DA Access Report

21050

198 Bennett Road, St. Clair, NSW

This Access Compliance Report is to accompany a Development Application for the development proposed at 198 Bennett Road, St. Clair, NSW

[Image description: Plan of Basement Level above shows the provision of Accessible parking spaces]

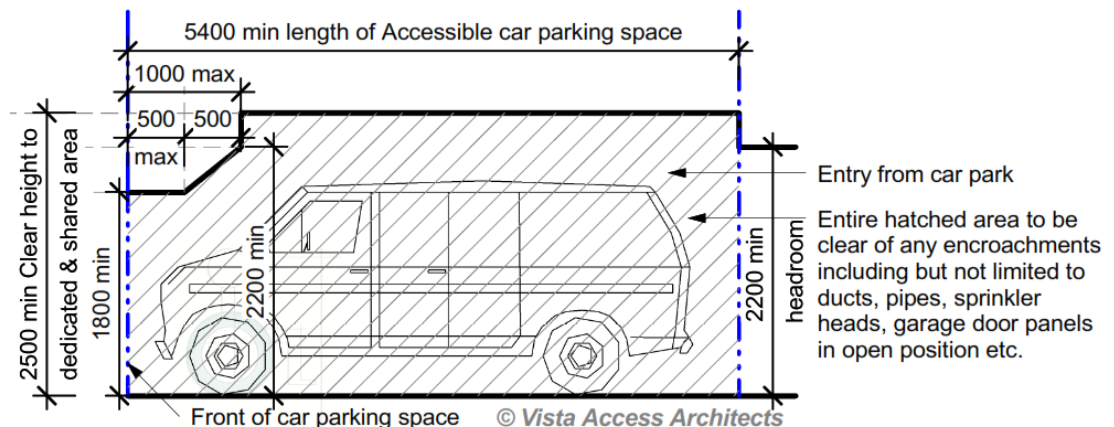
<b>BCA Part D3.5 Accessible Carparking</b>
<b>Requirement</b>	<b>Class 9b</b> School - 1 Accessible car parking space per 100 spaces provided Other assembly building - 1 Accessible car parking space per 50 spaces provided and then additional 1 Accessible car parking space per additional 100 spaces provided
<b>Compliance Comments</b>	Complies. Total number of Accessible parking spaces required / provided in the development = 1. Detailed features of the accessible parking space to be verified at CC stage of works.
